CERTIFICATE OF APPROPRIATENESS

Property: Lot 9, Block 230, Houston Heights South Subdivision. The property includes a one and a half-story wood frame 2,476 square foot single-family residence and detached garage situated on a 6,600 square foot interior lot.

Proposal: Replace (3) non-original windows West Elevation, facing street, on 2nd story dormer.

Proposed Kolbe Wood Window Specifications

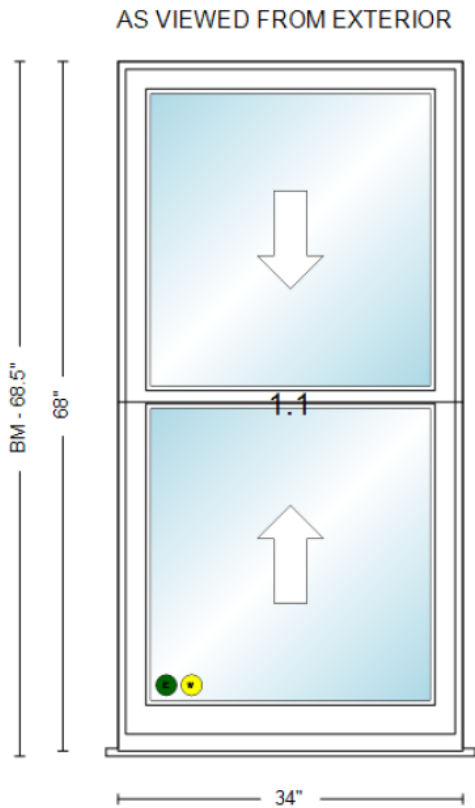
ALL NEW WINDOWS MUST BE INSET 1¾ Inches – See Attachment

1-over-1 Windows Must Be Equally Horizontally Divided

Historic Window Standard: New Construction & Replacement

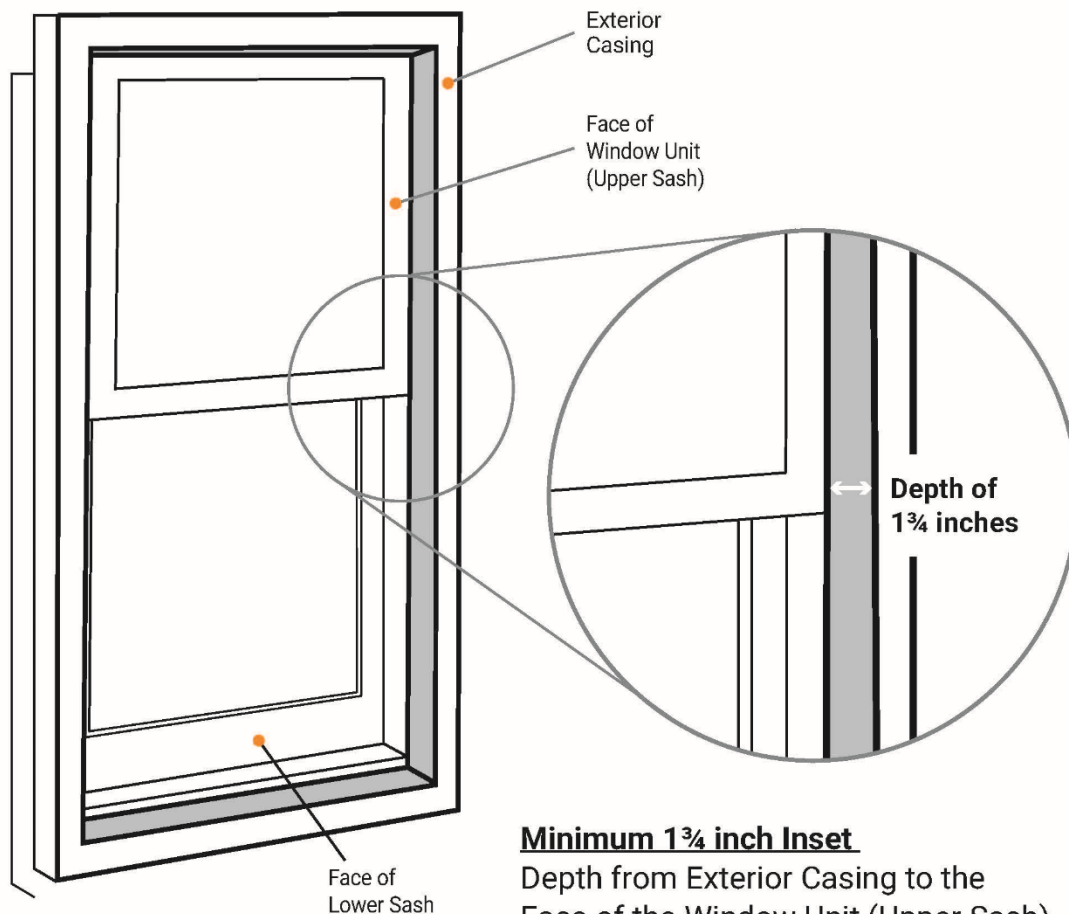
Minimum 1 3/4 inch Inset

Depth from Exterior Casing to the Face of the Window Unit (Upper Sash)

Windows must be 1-over-1
(equally horizontally divided)

1 3/4 inch minimum inset for Fixed Window
